1	7757	3/22/95	RE
REV	ECN	DATE	APV

THIS PRINT IS THE PROPERTY OF ITS CORP. IT SHALL NOT BE COPIED WITHOUT PERMISSION.				TITLE			
DATE	MATERIAL	DWN	SJM	5/26/94	DWG. NO.	1227-3237	REV
REV	FINISH	CHK	DWB	6/1/94	REL	DWB	1
REV	ECN	DATE	DATE	DATE	SCALE	---	SHEET 1 OF 1

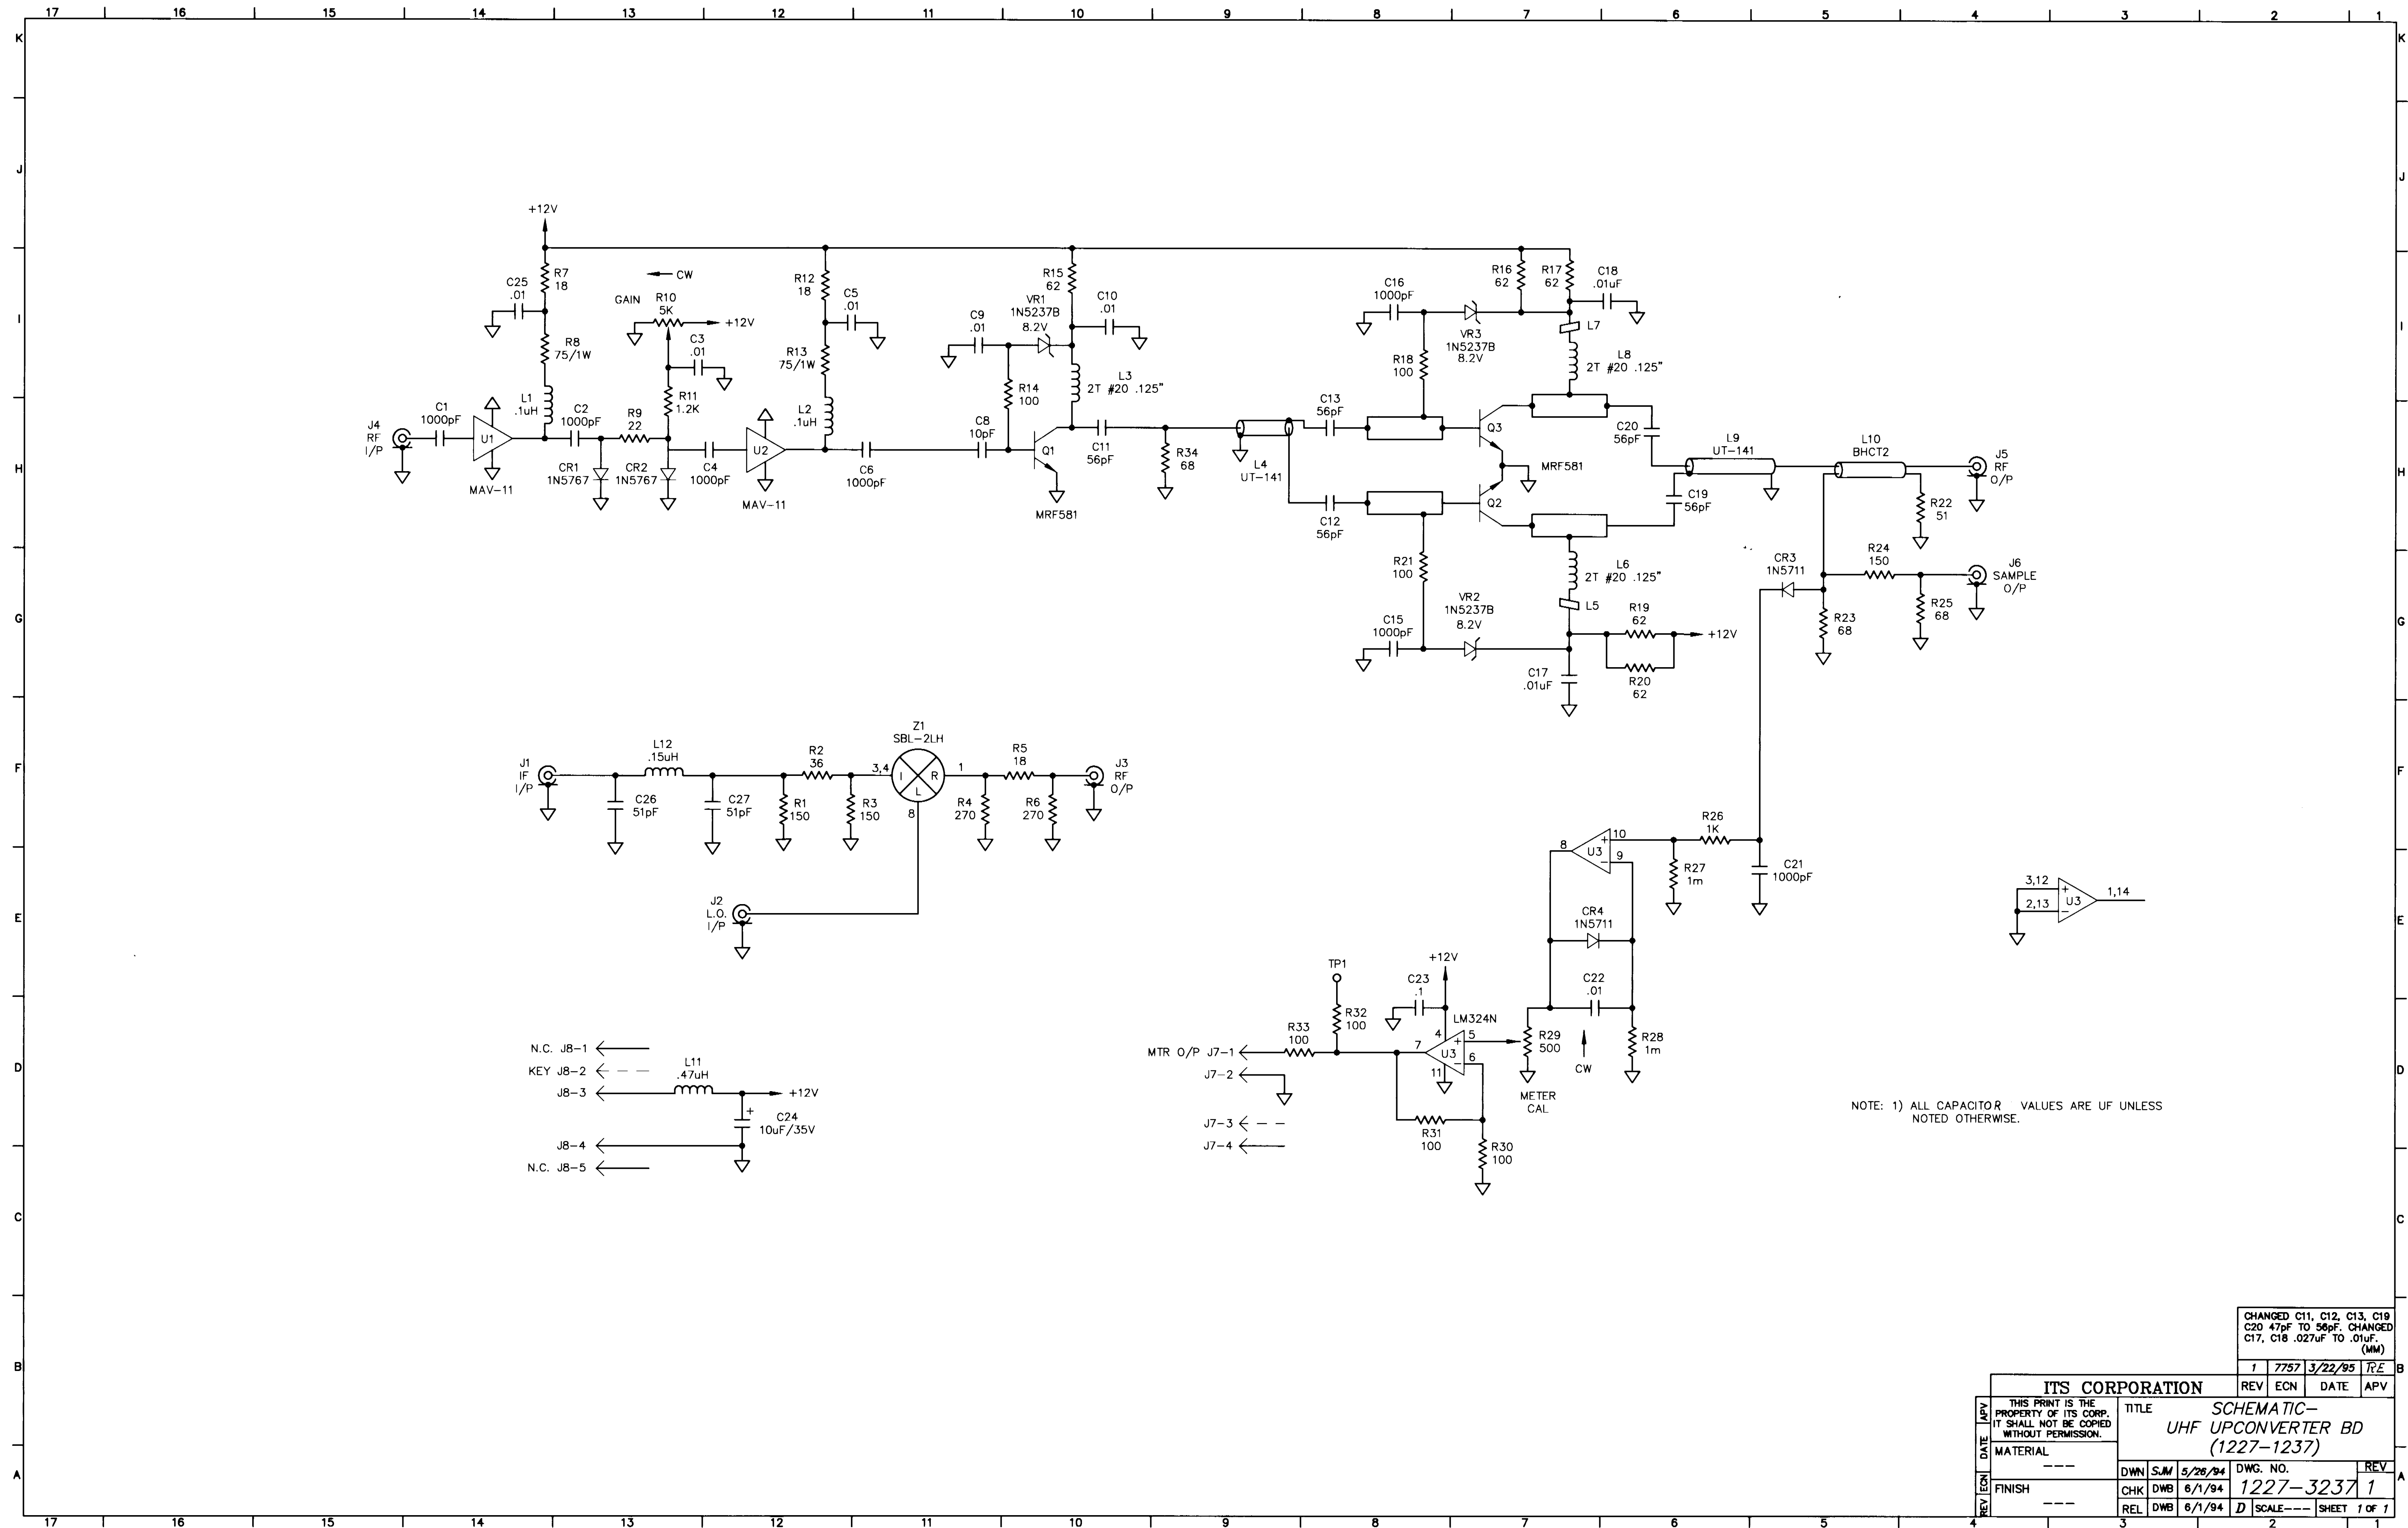
CHANGED C11, C12, C13, C19
C20 47pF TO 56pF, CHANGED
C17, C18 .027uF TO .01uF.
(MM)
